PERMIT # 301867

SEPTIC IMPROVEMENT PERMIT / AUTHORIZATION TO CONSTRUCT / OPERATION PERMIT / EXISTING SYSTEM

SUBDIVISION: Bethany Place | SECTION: | LOT # 5 | LOT AREA: .46 Acre | DESIGN FLOW: 360gpd | L.T.A.R.: .3

Septic Repair area modified to accomodate swimming pool. Energy United encroachment agreement attached.

See attached, approved Septic plan for relocation of repair Area

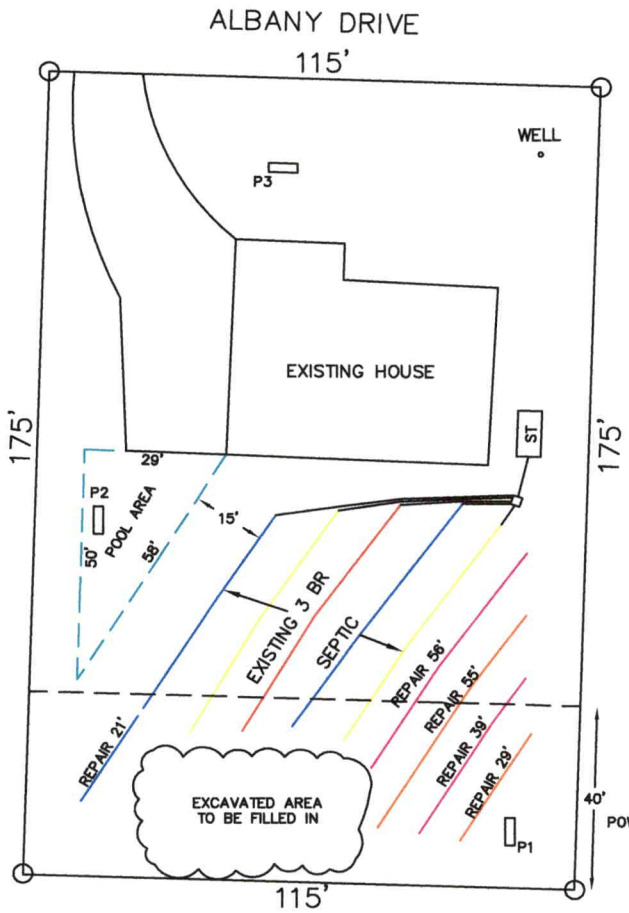
***EXISTING 3 BEDROOM SEPTIC NOT TO BE CHANGED. REPAIR (50% RED. @ .3 LTAR) CHANGED TO MAKE ROOM FOR POOL AS SHOWN.
***WATERS EDGE OF POOL MUST BE 15' FROM SEPTIC. POOL DECKING MUST BE 5' FROM SEPTIC.
